GE-NE-637-0005-0393, Rev. 1
DRF A00-05545
March 1993

**CORE SPRAY CRACK ANALYSIS
FOR
MONTICELLO NUCLEAR GENERATING PLANT**

Subject: Third Party Review of General Electric Evaluation Approach for Continued Operation of Cracked Core Spray Pipe at Monticello Nuclear Generating Plant

Figure 1
CRACK GROWTH RATE DATA

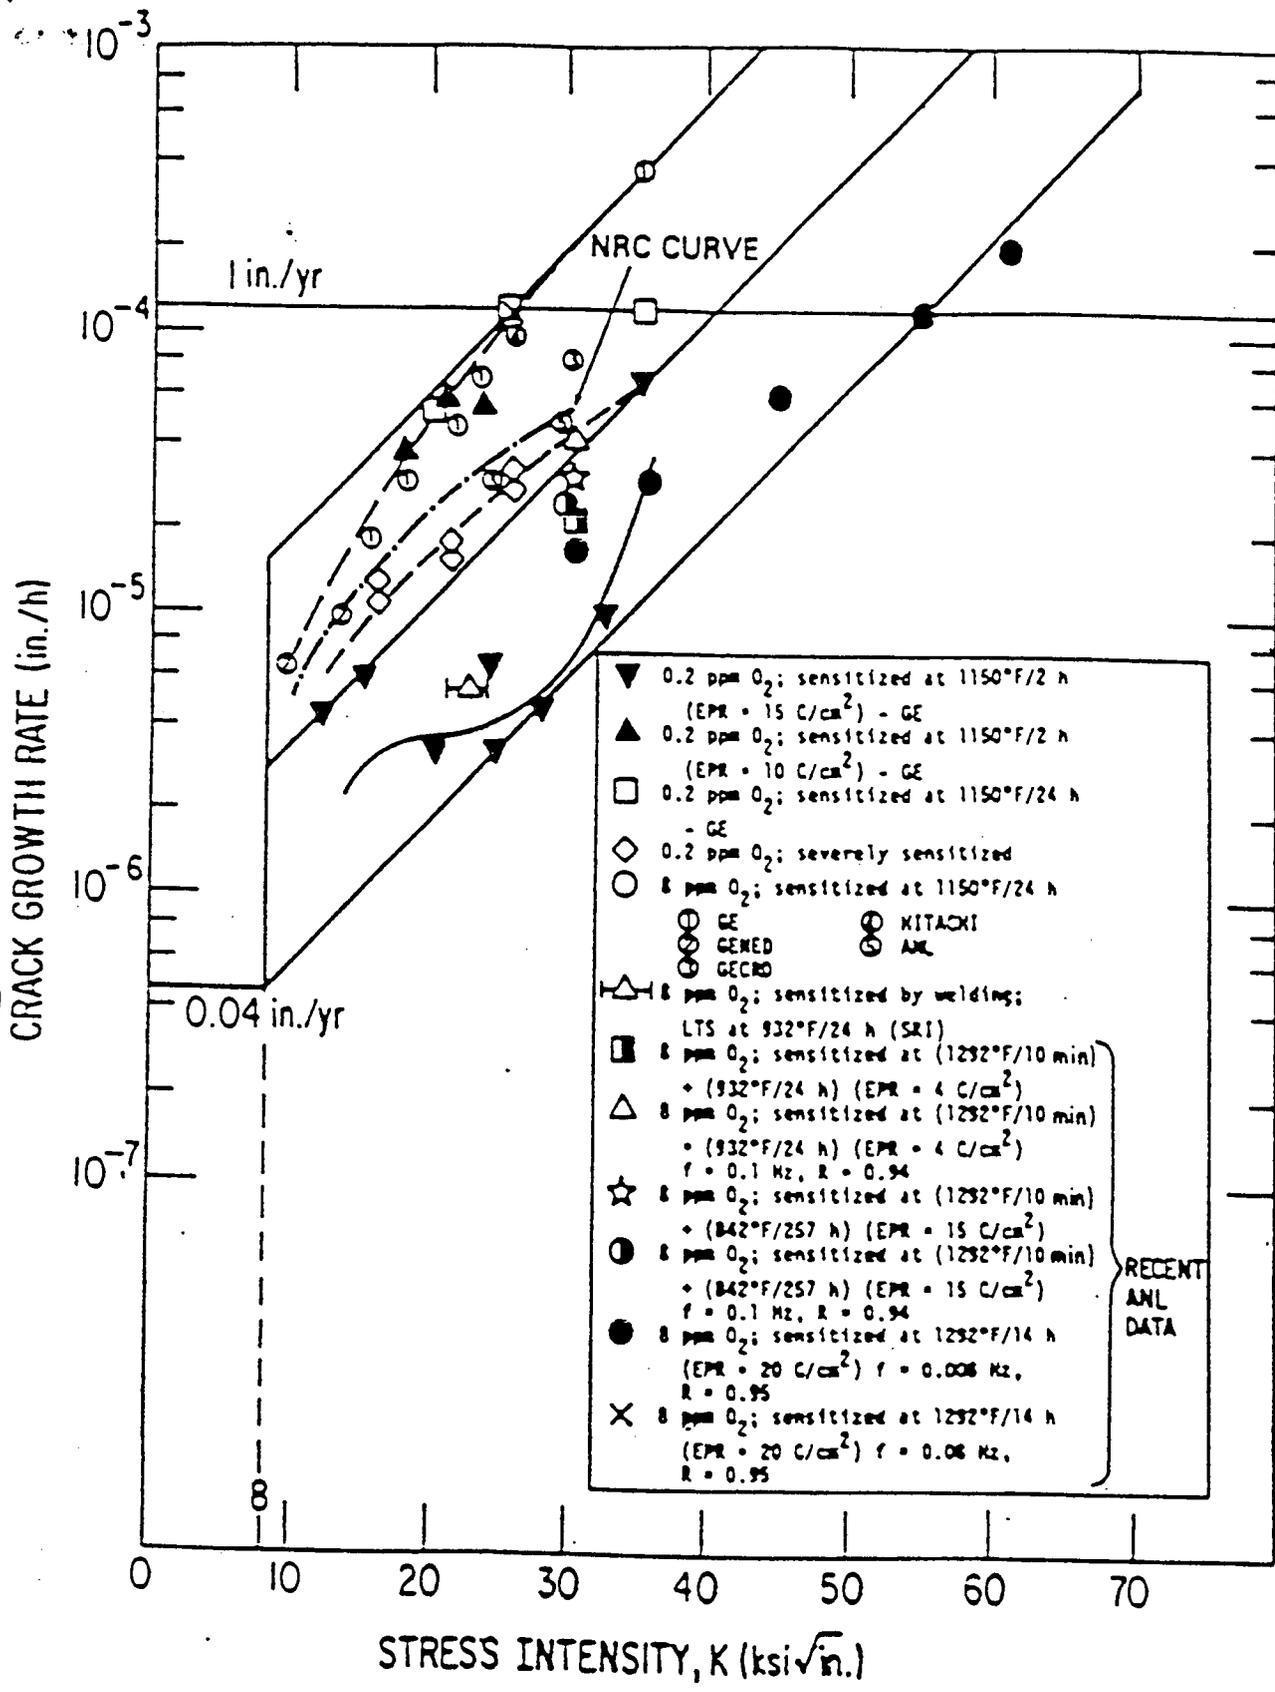
5. A conservatively predicted crack growth rate during the next fuel cycle would produce only an additional 1 to 1.5" of crack length. The crack growth rate was assumed to be an upper bound of 4×10^{-5} in/hr, independent of stress intensity, during the entire subsequent operating cycle. This estimate of crack growth rate is extremely conservative as illustrated by examining the NRC recommended curve in Figure 1, taken from NUREG-0313, Rev. 2.
